Access Compliance Report

Public Rights-of-Way

(Curb Ramps)

Intersection ID: 15839	Main Street: DORCHESTER_PL	Cross Street: SEDGEFIELD_RD	Location: NE
ADA ID: 85126A95DB7F	Ramp Type: Directional1	Initial Pass/Fail: Fail	Overall Compliance: No
Severity Score: 22.5			
Codes/Mitigation Info/Possible Solution		Field Measurements/Component Compliance

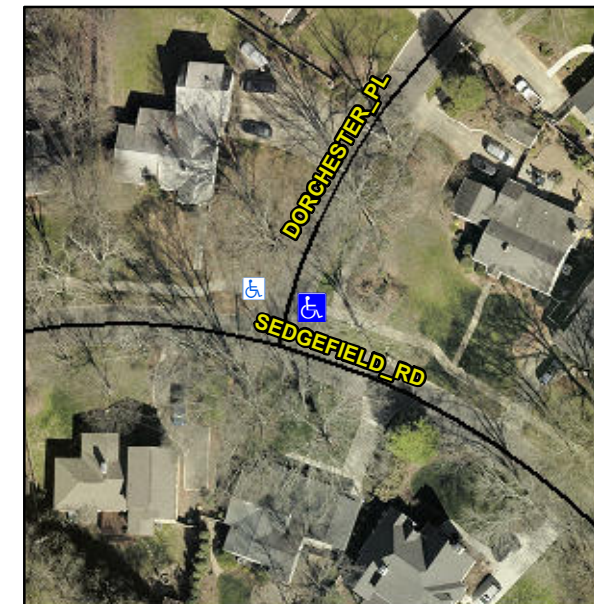
DAMAGED LT/RT FL

R304.5.1, R304.2.2, R304.5.3

Compliance	Description	Data	Compliance	Description	Data
N/A	Ramp Length (in)	64.0	N/A	Grade Break?	N/A
No	Ramp Width (in)	47.0	N/A	Grade Break Slope (%)	0.0
No	Ramp Slope (%)	10.5	N/A	Grade Break XSlope (%)	0.0
No	Ramp XSlope (%)	4.6			
N/A	Flare Type LT	N/A	N/A	Flare Type RT	N/A
N/A	Flare Slope LT (%)	N/A	N/A	Flare Slope RT (%)	0.0
N/A	Flare Traversable LT?	N/A	N/A	Flare Traversable RT?	N/A
N/A	Landing Length (in)	0.0	N/A	DWS Provided?	N/A
N/A	Landing Width (in)	0.0	N/A	DWS Contrast?	N/A
N/A	Landing Slope (%)	0.0	N/A	DWS Length (in)	N/A
N/A	Landing X Slope (%)	0.0	N/A	DWS Full Width?	N/A
N/A	Landing Curb? (Y/N)	N/A	N/A	DWS Offset LT (in)	N/A
N/A	Shared Landing?	N/A	N/A	DWS Offset RT (in)	N/A
N/A	Gutter Ponding?	0.0	N/A	Gutter Slope (%)	N/A
N/A	Gutter Lip Ht (in)	0.0	N/A	Gutter X Slope (%)	N/A
N/A	Painted X Walk1?	No		Road Slope (%)	0.1
	X Walk 1 Direction	To W		Road X Slope (%)	2.1
	X Walk 1 Width (in)	N/A		Clear Space?	N/A

Remove & Replace Entire Ramp.
